SUBJECT: FORWARDS RESPONSES TO QUESTIONS IN NRC 790130 LTR RE
 RADWASTE SOLIDIFICATION & HANDLING SYS.INCLUDES SPILL
 PREVENTION CONTROL & COUNTERMEASURE PLAN & NY APPLICATION
 FOR UNIT CONST PERMIT,INDIRECT SOURCE. *see Rpt*

Attached are responses to the questions enclosed
in your January 30, 1979 letter relating to the Radio-
active Waste Solidification and Handling System.

Nine Mile Point Unit 1

RADWASTE REDUCTION SYSTEM AND SOLIDIFICATION AND HANDLING SYSTEM

FIGURE 1

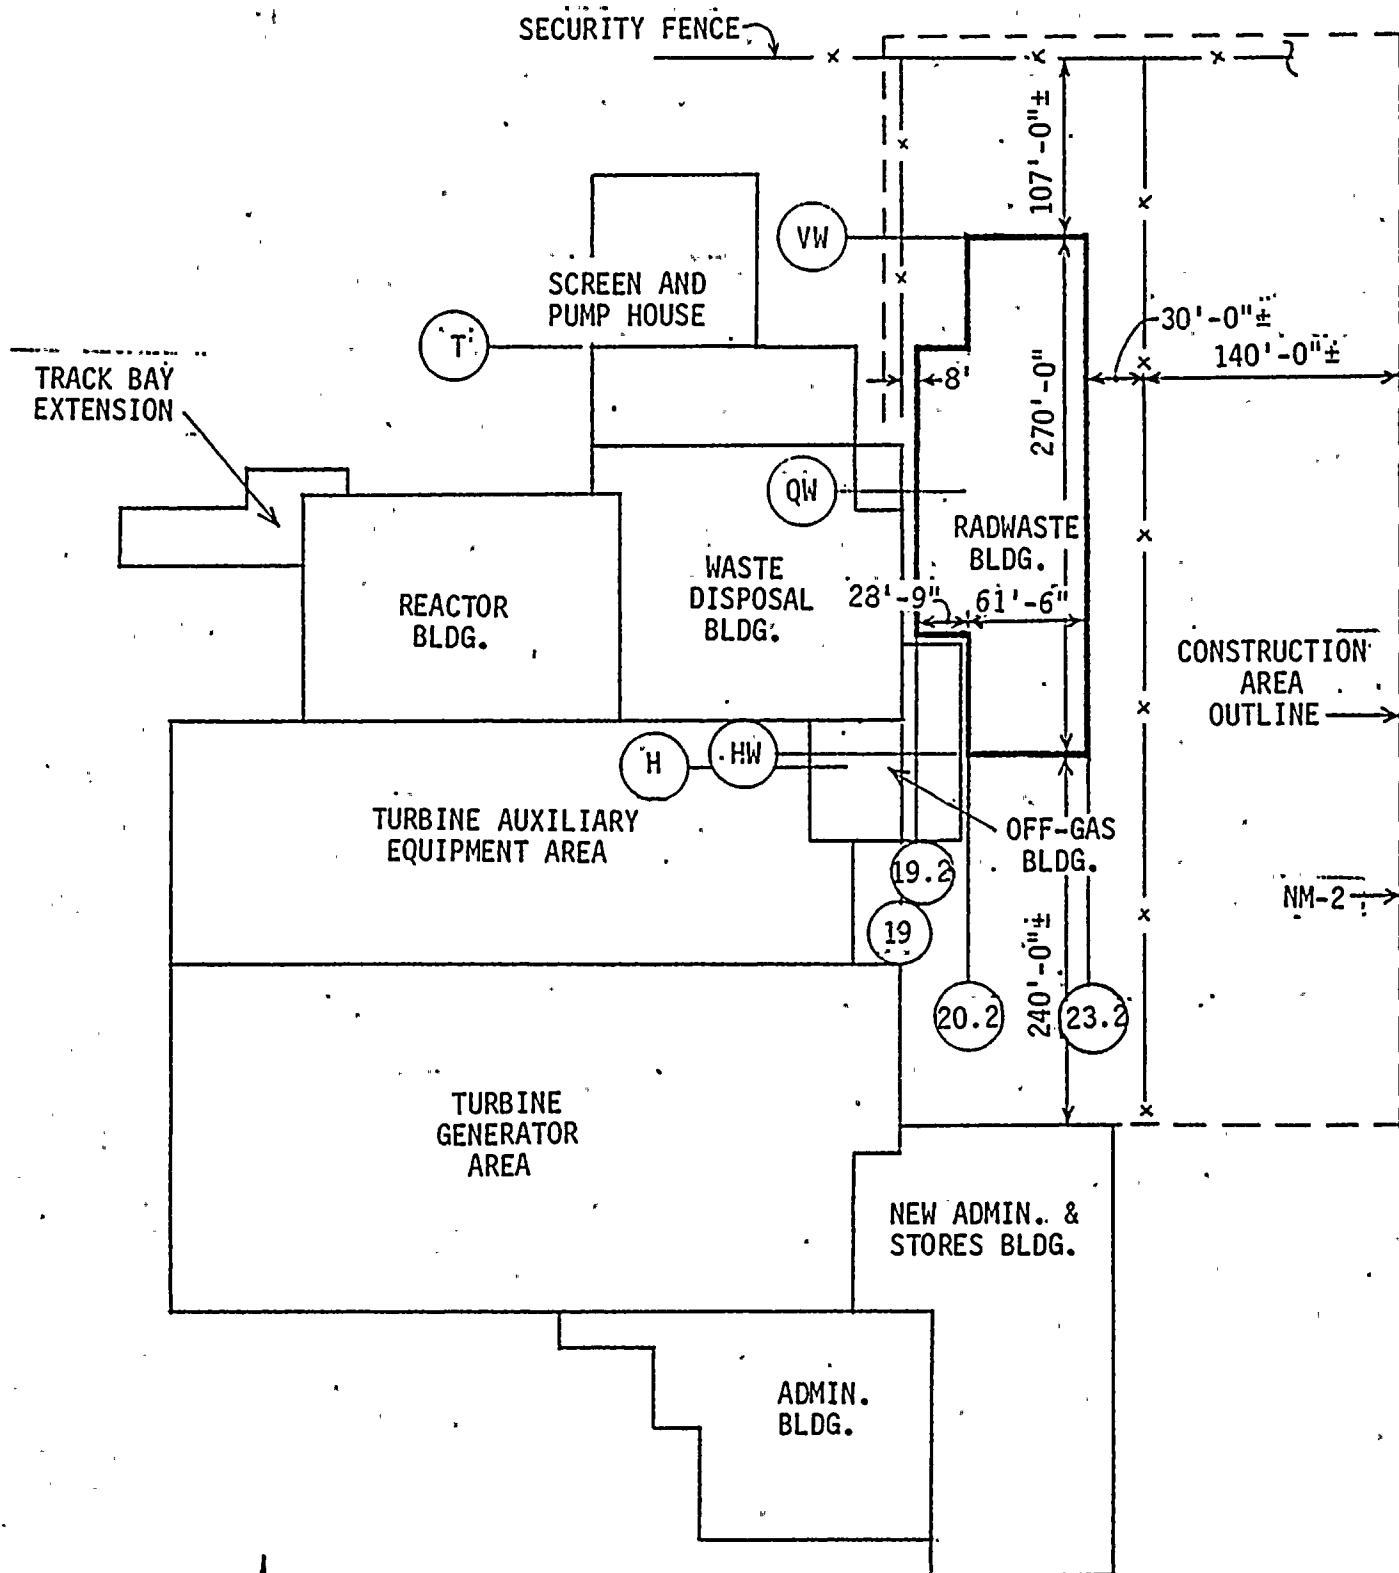
Provide a sketch to scale and with dimensions showing location of construction site and proposed building in relation to other existing facilities for NMP-1.

A sketch of the construction site and proposed building in relation to other existing facilities at Nine Mile Point Unit 1 is enclosed herein.

SECTION 2-2
(ELEVATION)

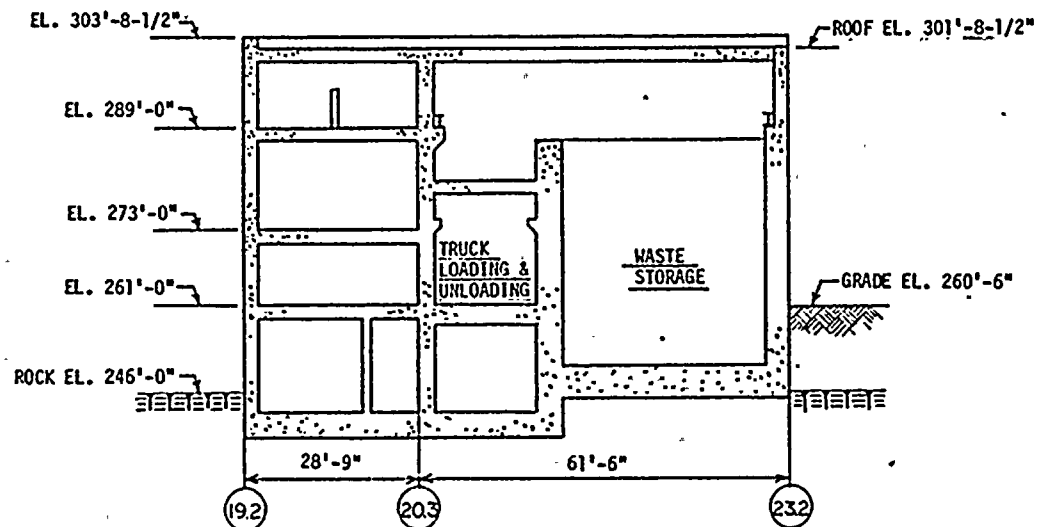
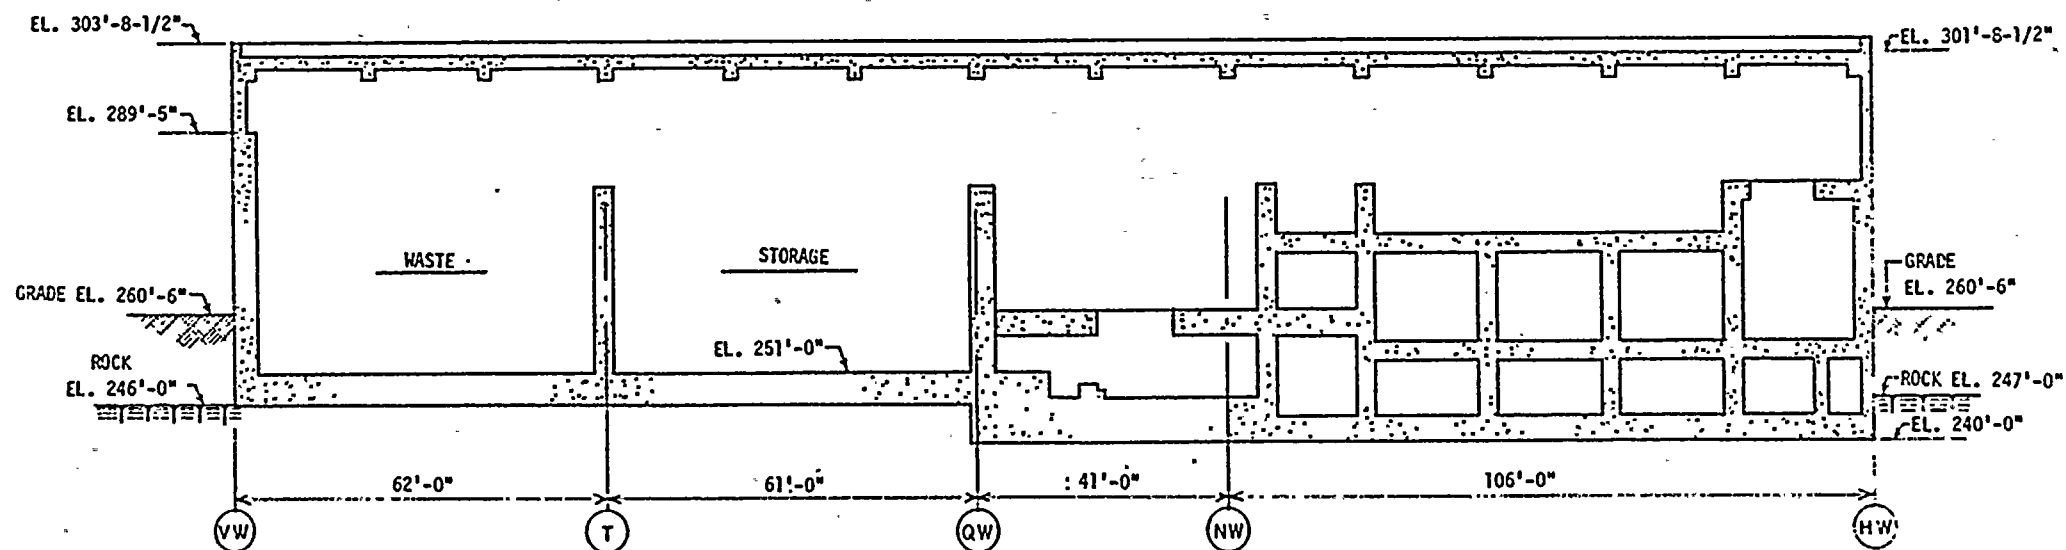
Provide a dimensioned sketch of the proposed building cross-section showing existing grade, depth of foundation with respect to surface soil and bedrock), and proposed finished grade.

A sketch of the proposed building cross-section showing existing grade, finished grade and depth of foundation is enclosed herein.
